# STANDARD PLANS SUMMARY

INTERSTATE ROUTE H-1 REHABILITATION
SALT LAKE BOULEVARD TO AIRPORT VIADUCT
FEDERAL-AID PROJECT NO. NH-H1-1(275)

# TYPICAL SECTIONS & DETAILS

## TYPICAL SECTION TEMPORARY PRIOR TO COLD PLANING
## ℄ STA. 43+60.00± TO ℄ STA. 55+20.00± Lt.
## ℄ STA. 47+20.00± TO ℄ STA. 55+20.00± Rt.

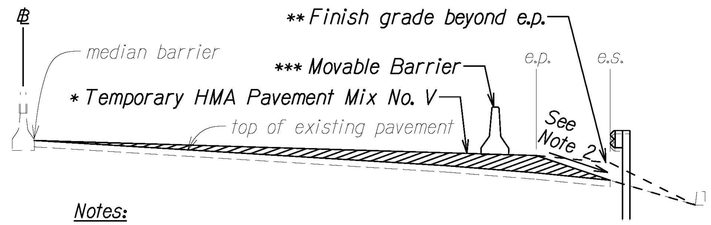
| DATE | REVISION |
|---|---|
| 1 11/10/21 | Revised Typical Section Temporary Prior to Cold Planing Note 3. |

1 *** 3. Movable Barrier shall be installed once temporary HMA Pavement Mix No. V is placed to finish grade. Deploy movable barrier to shield active Reconstruction Work Area. Movable Barrier shall be moved to stored position during periods of time when lane closure is not allowed. Do not remove Movable Barrier from site until the new MGS guardrails within the Reconstruction Work Area are completed in place. For Temporary Barrier Plans, See Sheets 29 - 30.

## RECONSTRUCTION OF EXISTING ASPHALT CONCRETE GUTTER TYPE 7 (6' TO 8')

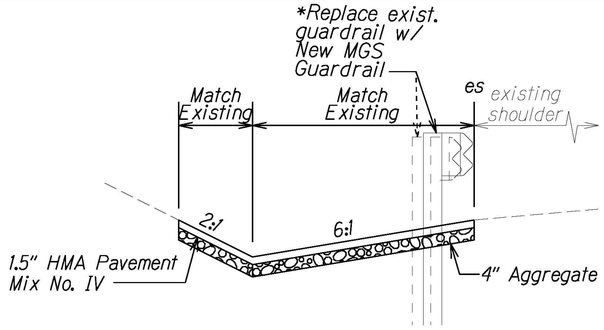
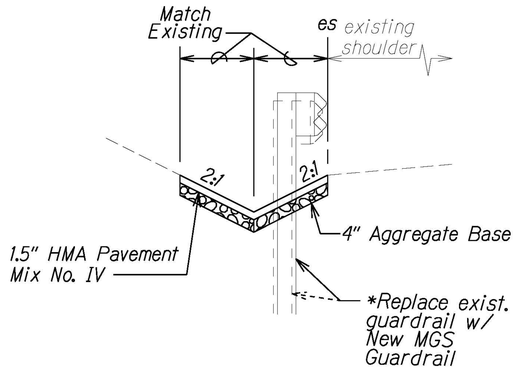
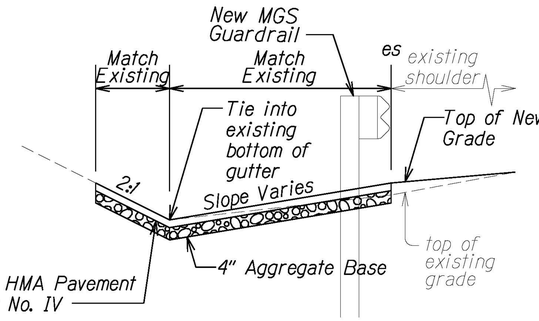
| /1 | 11/10/21 | Added Asphalt Concrete Gutter Notes 4, 5, and 6. Rearranged detail positions on this sheet. |

/1 4. From ℄ Sta. 53+04± to ℄ Sta. 55+22± Lt. and ℄ Sta. 59+54± to ℄ Sta. 66+25± Lt., payment shall be under Item No. 639.1000 - Reconstruct Existing Asphalt Concrete Gutter (6 to 8 Feet).
5. From ℄ Sta. 55+58± to ℄ Sta. 59+13± Lt., payment shall be under Item No. 639.2000 - Reconstruct Existing Asphalt Concrete Gutter (4 to 5.99 Feet).
6. From ℄ Sta. 55+22± to ℄ Sta. 55+58± Lt. and ℄ Sta. 59+13± to ℄ Sta. 59+54± Lt., payment shall be under Item No. 639.3000 - Reconstruct Existing Asphalt Concrete Gutter Transition.

1 MOVABLE BARRIER POSITION FOR GRADE WORK DETAIL (INBOUND)
Scale: N.T.S.

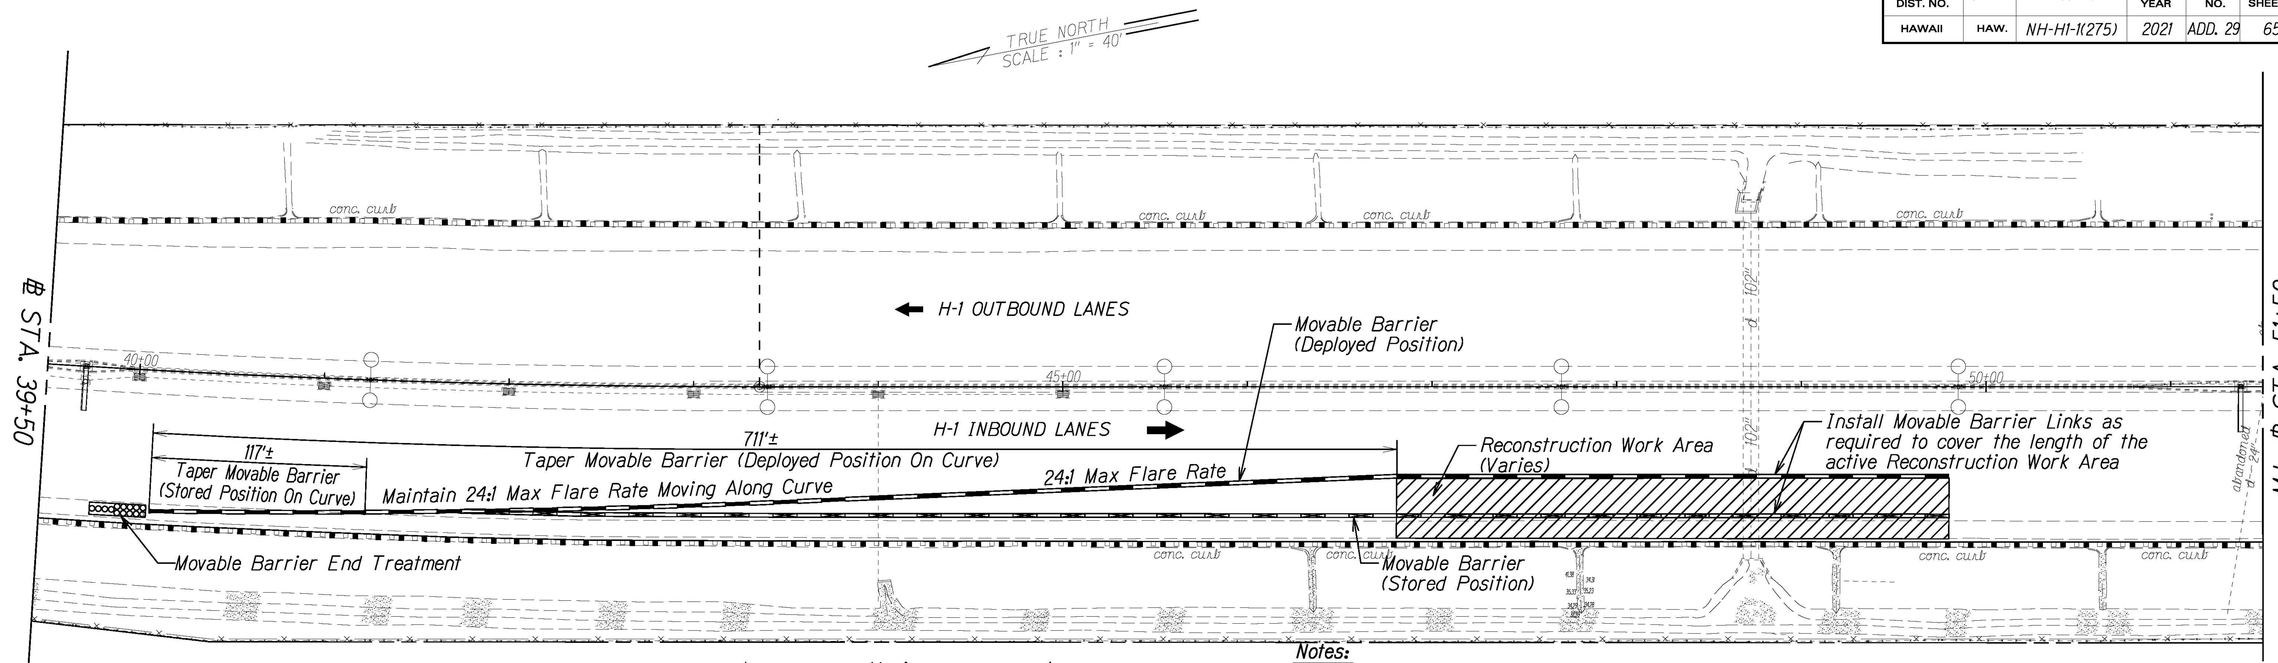
| | DATE | REVISION |
|---|---|---|
| 1 | 11/10/21 | Movable Barrier Position For Grade Work Details were swapped between sheets 29 and 30. Revised Detail Note 3. |

1 *** 3. Movable Barrier shall be installed once temporary HMA Pavement Mix No. V is placed to finish grade. Deploy movable barrier to shield active Reconstruction Work Area. Movable Barrier shall be moved to stored position during periods of time when lane closure is not allowed. Do not remove Movable Barrier from site until the new MGS guardrails within the Reconstruction Work Area are completed in place.

## 1 MOVABLE BARRIER POSITION FOR GRADE WORK DETAIL (OUTBOUND)

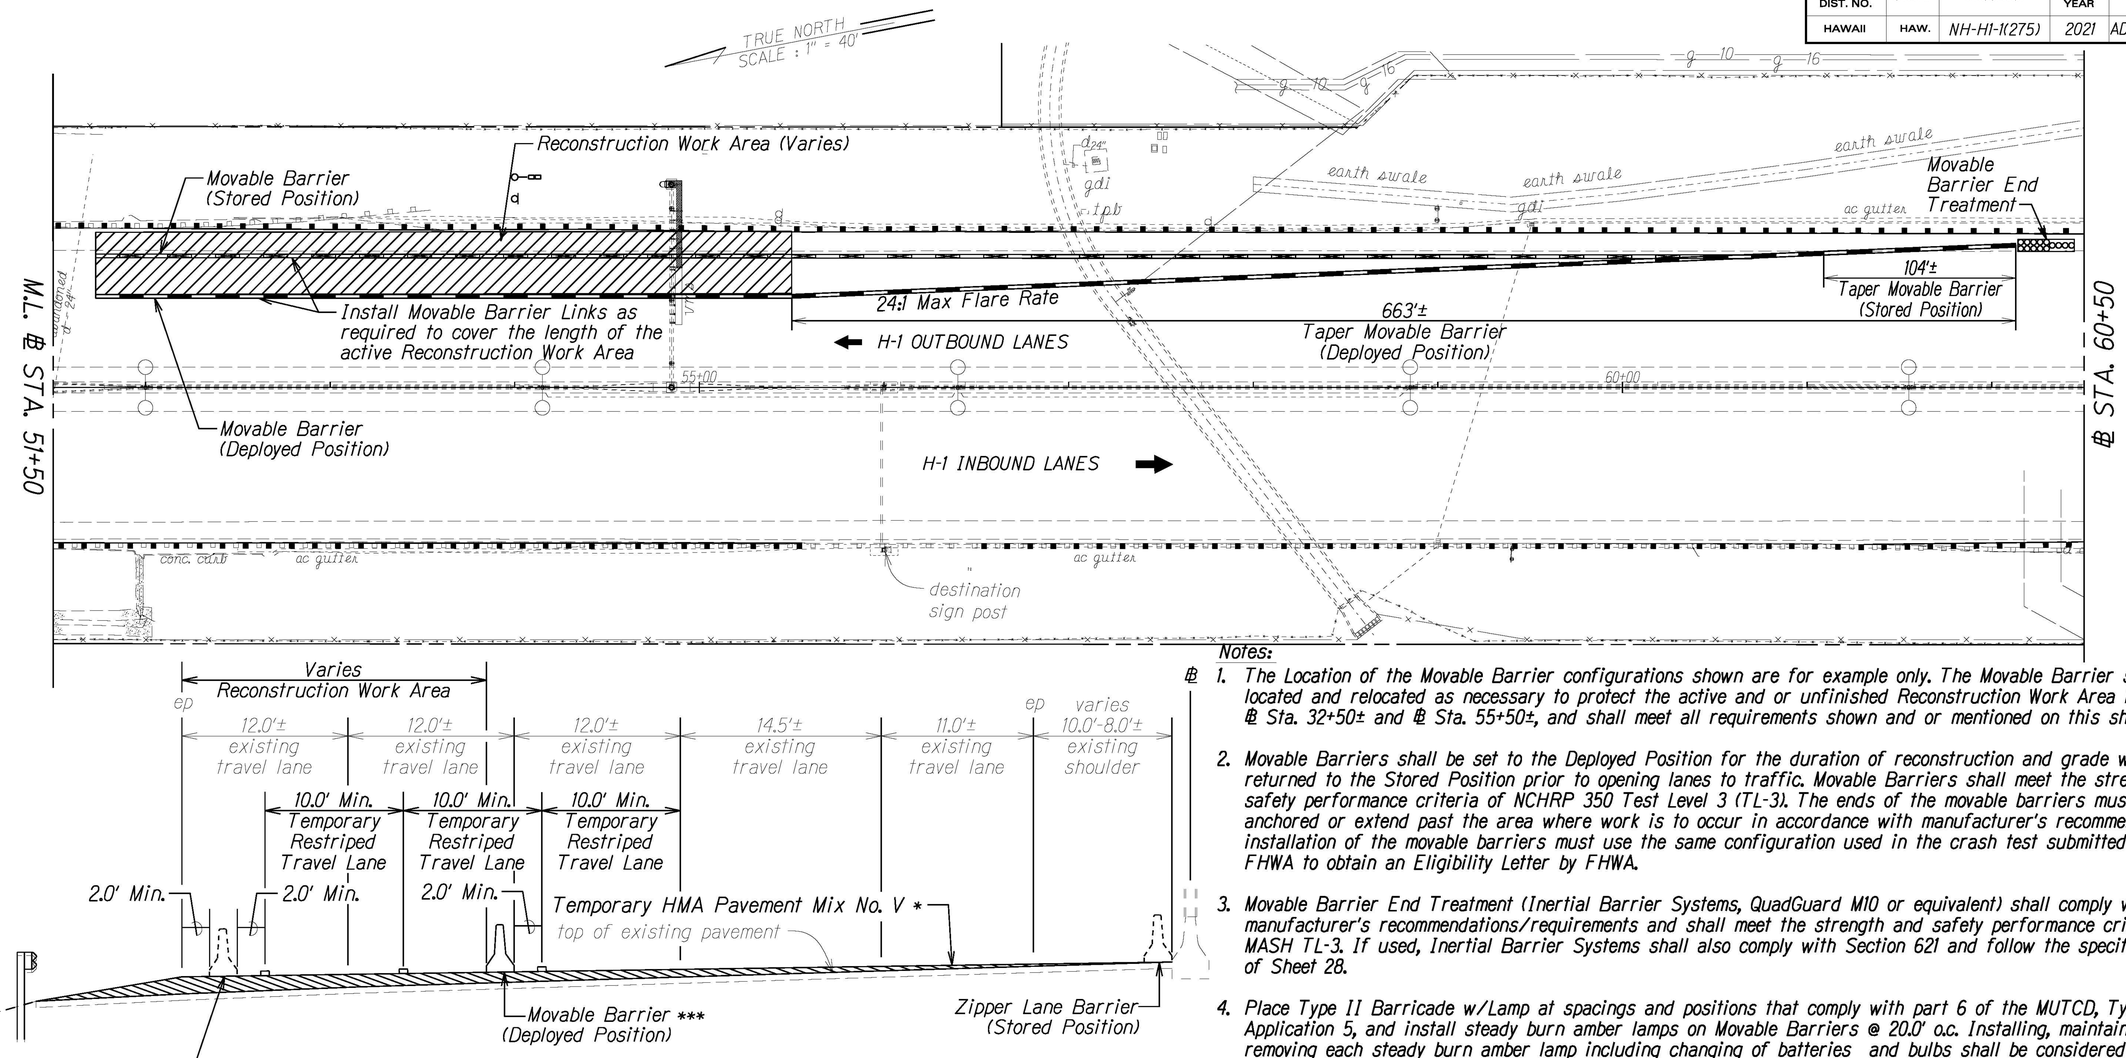
| DATE | REVISION |
|---|---|
| 1 11/10/21 | Movable Barrier Position For Grade Work Details were swapped between sheets 29 and 30. Revised Detail Note 3. |

1 *** 3. Movable Barrier shall be installed once temporary HMA Pavement Mix No. V is placed to finish grade. Deploy movable barrier to shield active Reconstruction Work Area. Movable Barrier shall be moved to stored position during periods of time when lane closure is not allowed. Do not remove Movable Barrier from site until the new MGS guardrails within the Reconstruction Work Area are completed in place.

# ROADWAY PLANS

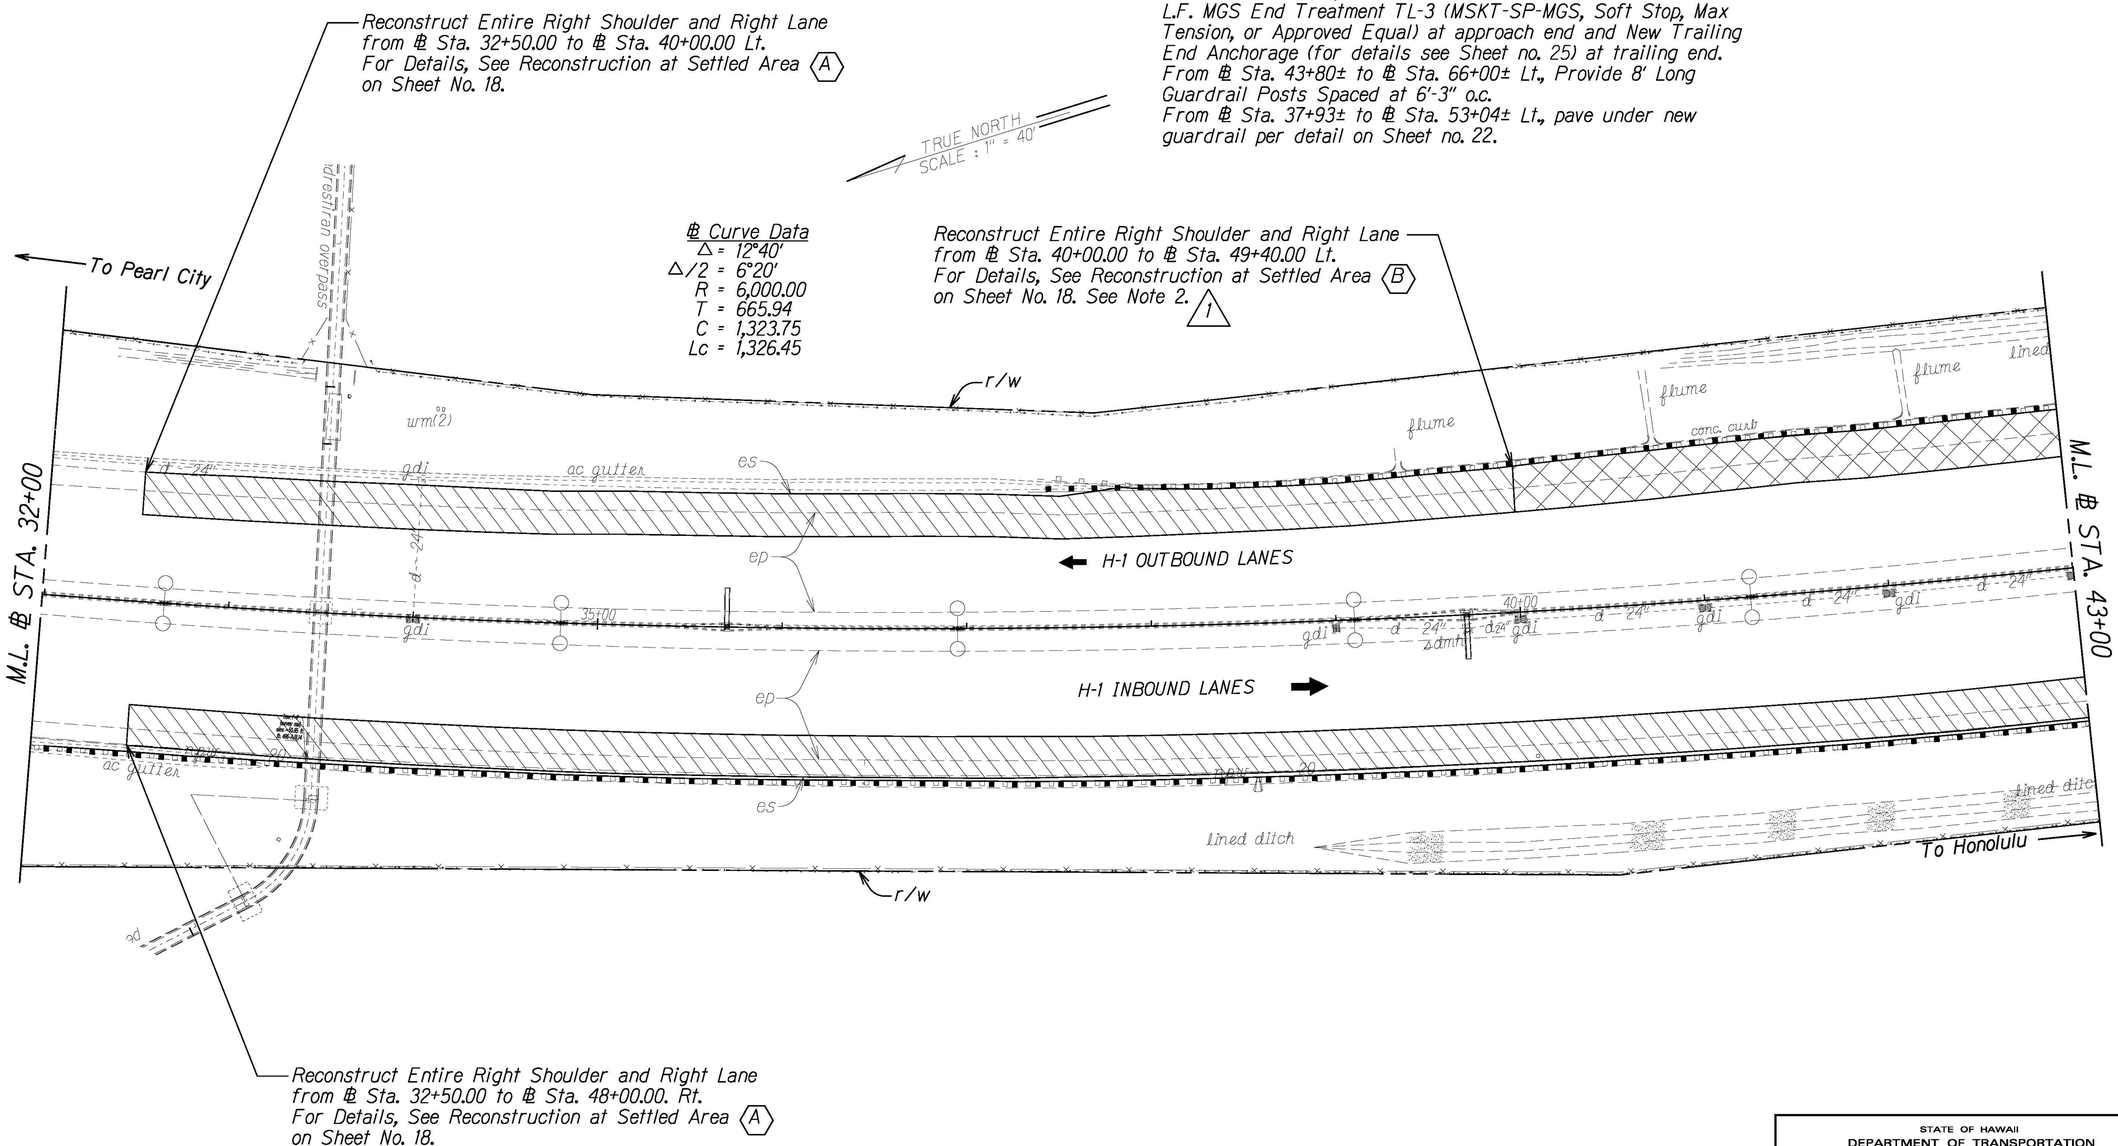
| 1 | 11/10/21 | Added Note 2. |

1. Removal and disposal of existing guardrail and end treatments shall be incidental to pay Item 606.1000 - MGS Guardrail (Type 3) or Item 606.1100 - MGS Guardrail (Type 3) with 8' posts at 6'-3" o.c.
2. The Contractor shall use care when excavating around existing utilities. See General Notes #12 and #15. 1

# ROADWAY PLANS

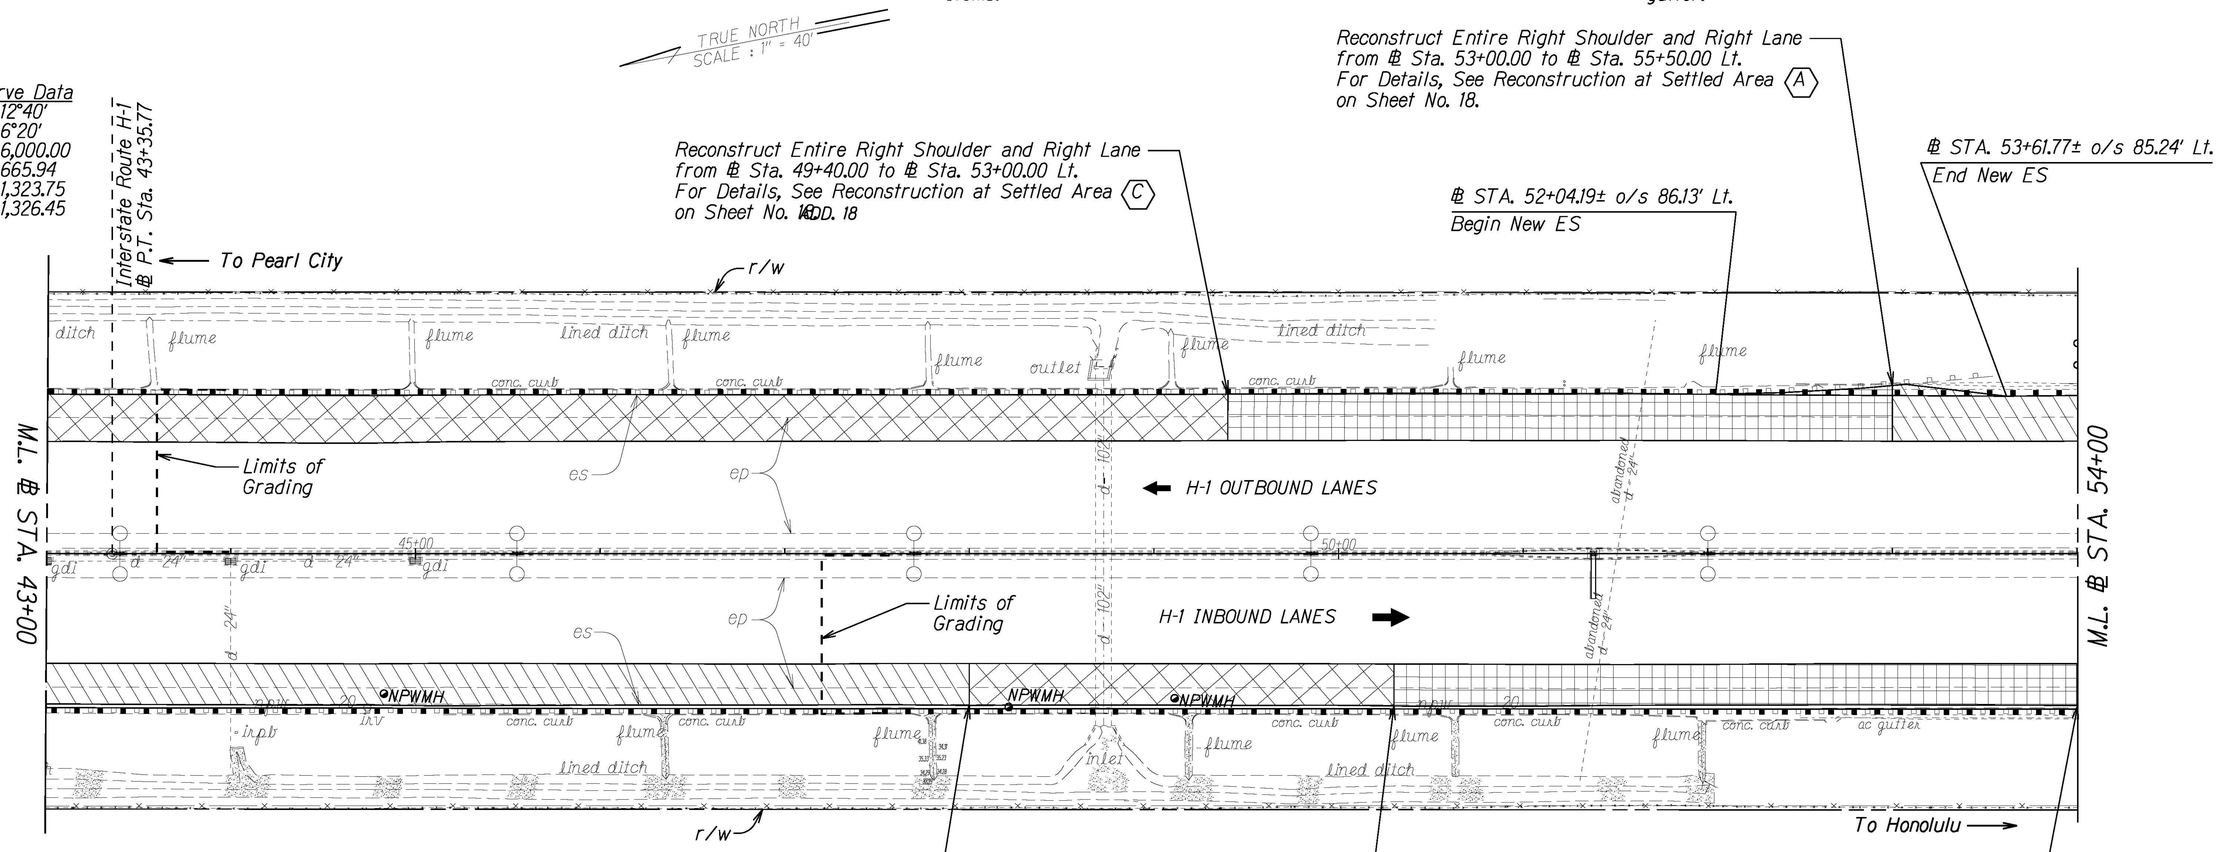
| DATE | REVISION |
|---|---|
| 1 11/10/21 | Added Note 2.<br>Added Note 3.<br>Added Note 4. |

2. The Contractor shall use care when excavating around existing utilities. See General Notes #12 and #15. 1
3. For excavation around existing manholes, soil shall be excavated such that the level of soil surrounding the manhole is equal all around. The Contractor shall protect existing manholes and utilities. Any damages incurred shall be repaired or replaced at the cost of the Contractor. 1

4. The water valves in the vicinity shall be shut off during exposure of waterline during reconstruction work. Should the bottom of the existing waterline become exposed, it shall be supported and protected. Any damages incurred shall be repaired or replaced at the cost of the Contractor. Ensure proper compaction around existing pipes. 1

# ROADWAY PLANS

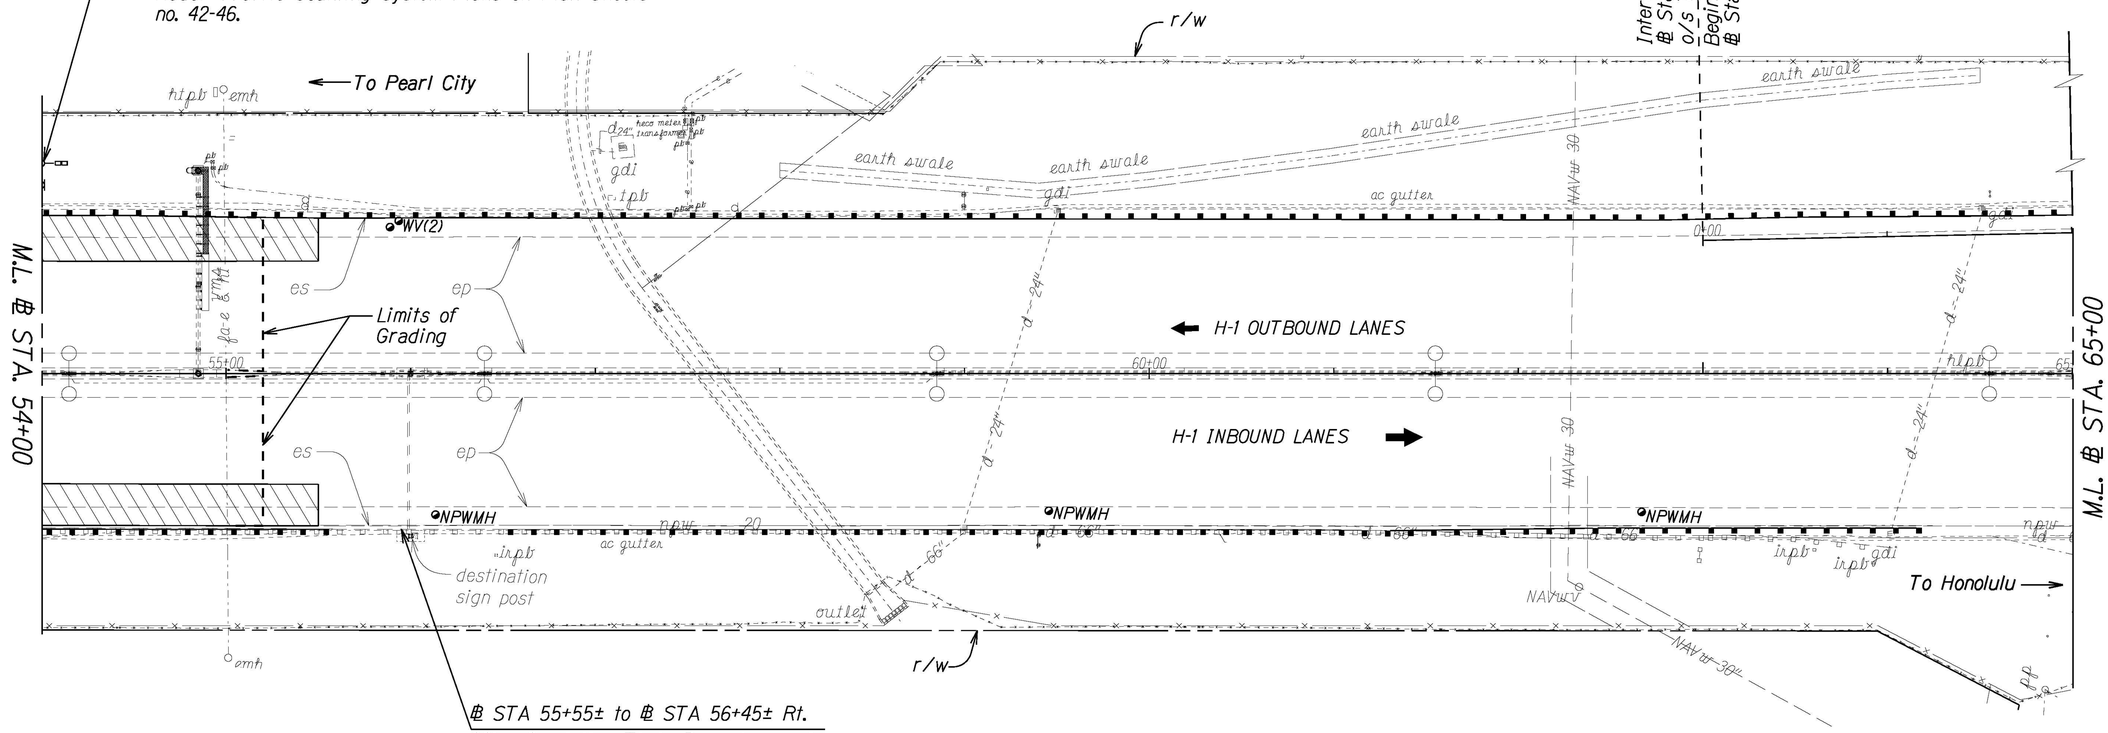
| DATE | REVISION |
|---|---|
| 11/10/21 | 1 Clarified Radar Traffic Counting System Plans are on Plan Sheets no. 42-46 and added approximate ℄ Sta. for the pole. |

1 ℄ STA 54+00±, o/s 40.0'± Lt. from ep

Install two (2) new Radar Vehicle Sensing Devices banded to new 30' pole, two (2) new Controller Cabinets on new concrete foundations and new Excavation Warning Signs on post. For details, see Radar Traffic Counting System Plans on Plan Sheets no. 42-46.
